# Service Bulletin

Bulletin No.: 19-NA-277

**Subject: Poor Fuel Transfer and/or Rear Fuel Tank Collapsed**

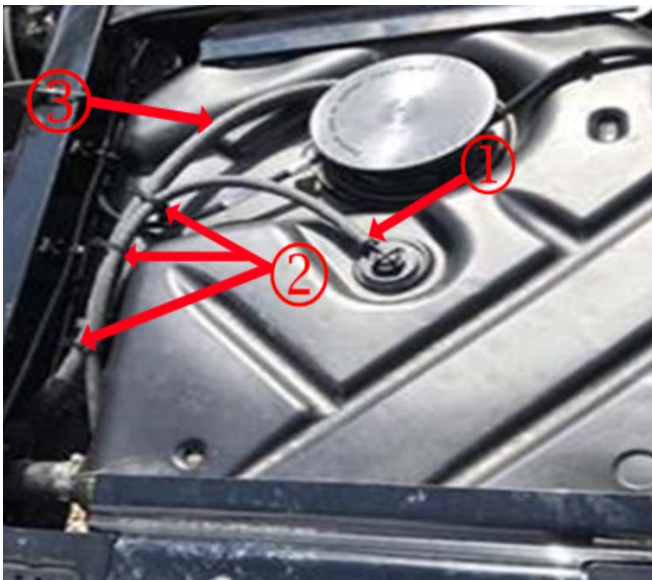
<b>Involved Region or Country</b>	North America
<b>Additional Options (RPOs)</b>	Equipped with FUEL TANK-DUAL TANK, FRONT TANK 23.5 GAL (89L) REAR TANK 40 GAL (151L) (RPO N2N)
<b>Condition</b>	 <p style="text-align: right; font-size: small;">5396125</p> <p>Some customers may comment on the rear fuel tank collapsed, as shown in the picture above.</p>

<p><b>Cause</b></p>	 <p style="text-align: right;">5397974</p> <p>This condition may be caused by dirt and/or debris collecting on the top of the rear tank (1), plugging the vent causing the sending unit to draw air and bend the fuel tank fuel pump (2), as shown in the picture above.</p>
<p><b>Correction</b></p>	<p>Replace the fuel tank, sending unit and install a piece of fuel hose to the vent and route down the fuel feed line and secure with zip ties, following the procedure listed below.</p>

1. Drain the remaining fuel from the fuel tank. Refer to *Fuel Tank Draining* in SI.
2. Lower the fuel tank. Refer to *Fuel Tank Replacement* in SI.
3. Remove the fuel tank fuel pump module from the fuel tank, Refer to *Fuel Tank Fuel Pump Module Replacement* in SI.
4. Install the new fuel tank fuel pump module into the new fuel tank.
5. Cut one piece of KENT Lawson fuel line hose P/N 6637 or equivalent, 74 cm (29 in) and install one end to the vent (1) then route using 3 zip ties (2) down the fuel feed line (3), as shown in the picture above.
6. Reinstall the new fuel tank. Refer to *Fuel Tank Replacement* in SI.
